## SERVICE BULLETIN

ENGINE - MAIN GEARBOX ASSEMBLY - PROVIDE A MODIFIED VSCF SHAFT PLUG ASSEMBLY -  
CATEGORY CODE 8 - MOD.ENG-72-0232

V2500-ENG-72-0232

installation of VSCF shaft plug assy  
Fig.1

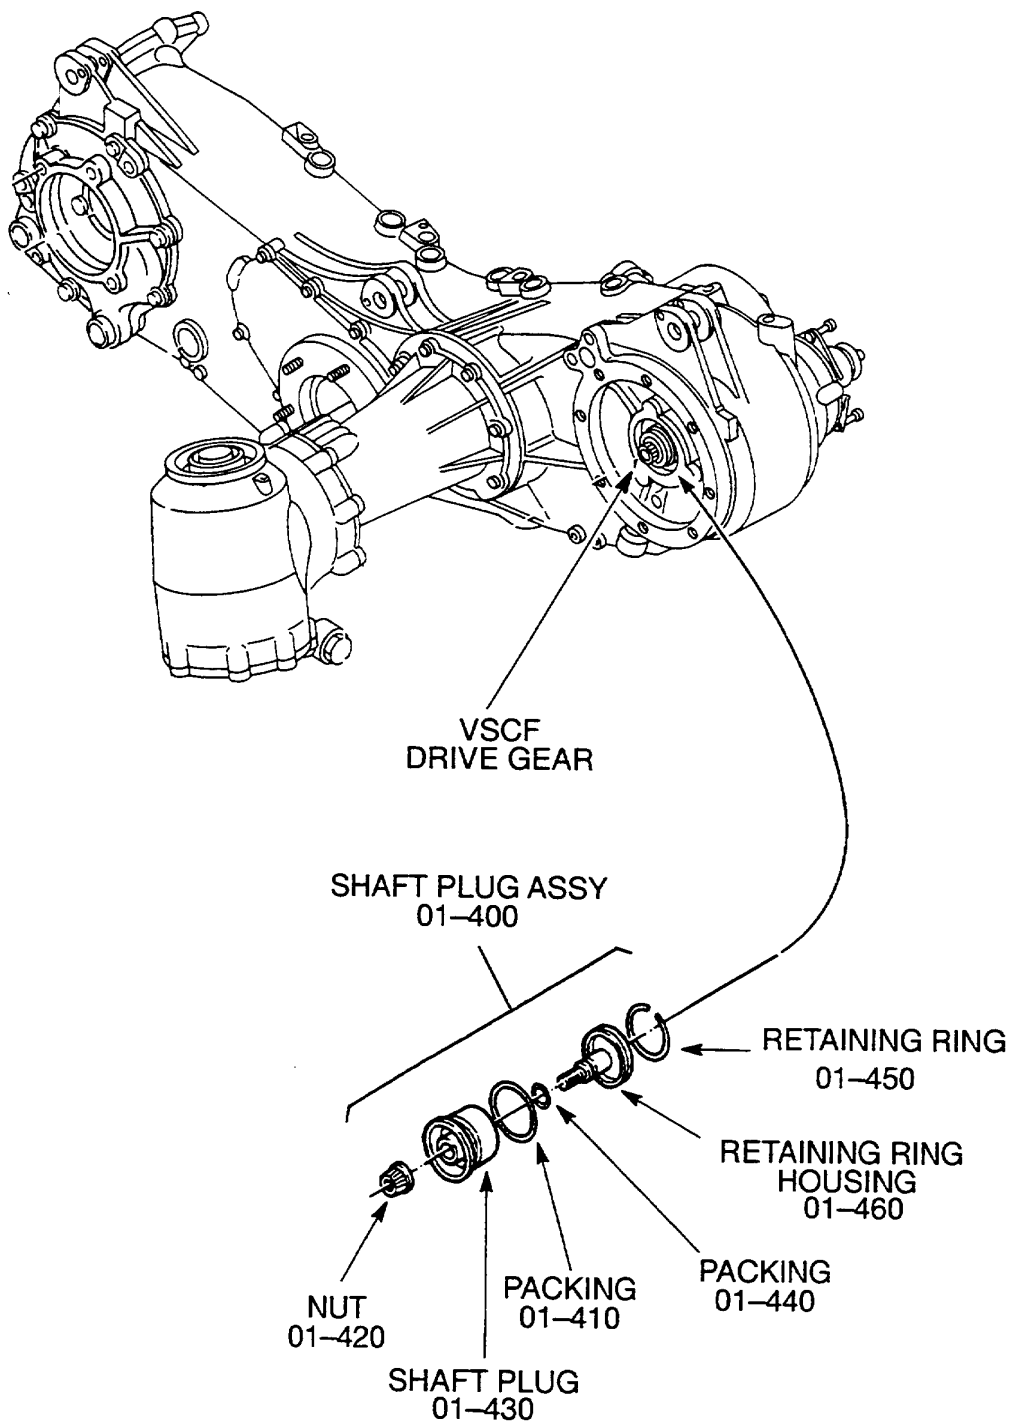
To introduce a revised plug assembly which eliminates the interference condition.

- Introduce a revised plug assembly for installation in the VSCF drive gear on the gearbox
- Allows installation of the plug assembly for up to four consecutive revenue flights back to a main maintenance station, if there is a requirement to make a failed VSCF inoperative

- (1) Make sure that proper o-ring seals are installed on the retaining ring housing and on the shaft plug. See Figure 1
- (2) Tighten the nut until the mating faces of the nut, shaft plug, retaining ring and retaining ring housing touch. Make sure that the retaining rings is evenly seated between the retaining ring housing and the shaft plug.
- (3) Install the preassembled shaft plug assembly into the VSCF drive gear.
- (4) Push the shaft plug assembly into the gear until it touches the ID spline in the gear.
- (5) Hold the retaining ring housing and torque the nut to 290 to 370 lbfin.
- (6) Make sure that the plug assembly is tight in the VSCF drive gear.
- (7) Put a notice in the Aircraft Log that the plug assembly is installed.
